Subject: Proposed Transfer of Facility Operating License R-130, McClellan Nuclear Radiation Center (MNRC)

Attachment:  
Changes to the License

TECHNICAL SPECIFICATIONS  
FOR THE  
U.C. DAVIS MCCLELLAN NUCLEAR RADIATION CENTER (MNRC)

Figure 6.1

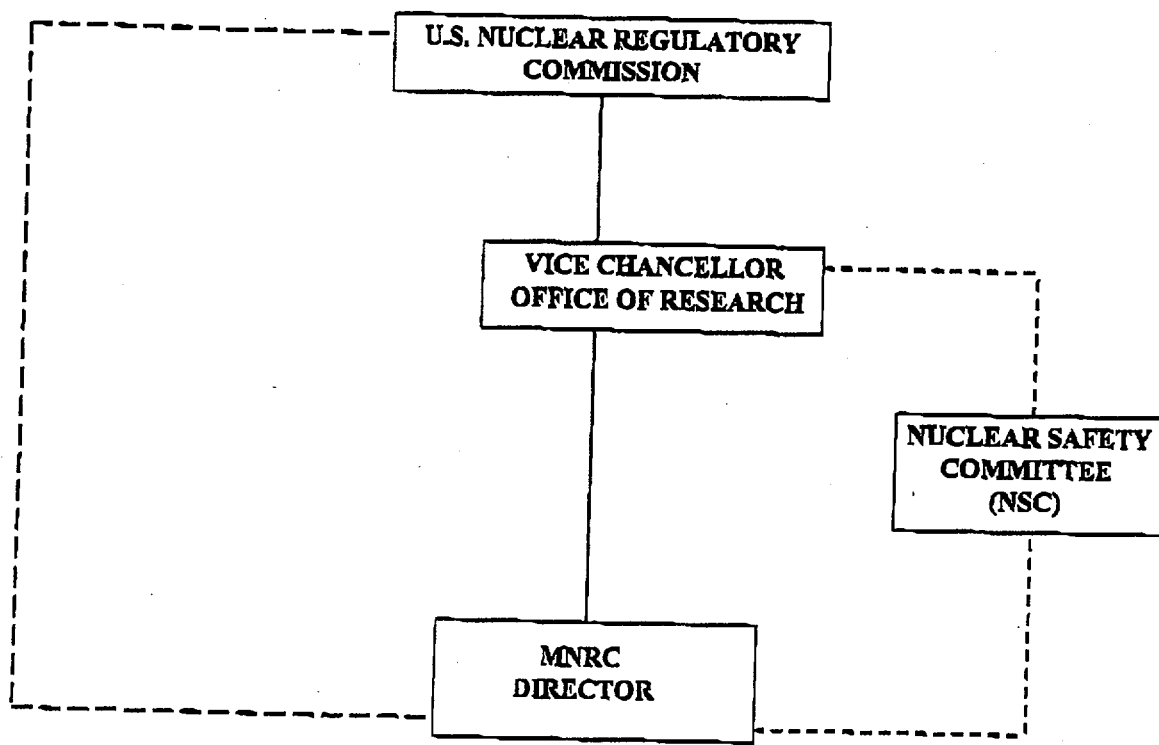
This is to supplement our letter of 13 Apr 99, and subsequent filings with regard to the transfer of Facility Operating License R-130 to the University of California. The attachments hereto explicitly show the proposed changes to the license that would be necessary to reflect the transfer of the license. Our 13 Apr 99 submittal, while requesting that the NRC transfer the license with the University of California, Davis, indicated as the licensee, inadvertently omitted the attachments as part of the initial application for approval of the license transfer which encompassed a conforming amendment request more explicitly detailed here.

The following additional information is supplied in support of the amendment and transfer application. As indicated in the proposed Technical Specifications, I will remain as the on-site Director of the MNRC but as an employee of the University of California. All other current employees, including supervisors, will remain in their present positions. However, they will become employees of the contractor Science Applications International Corporation (SAIC), which will operate the facility under the ultimate control and director of the University of California. My responsibilities as facility Director will remain unchanged.
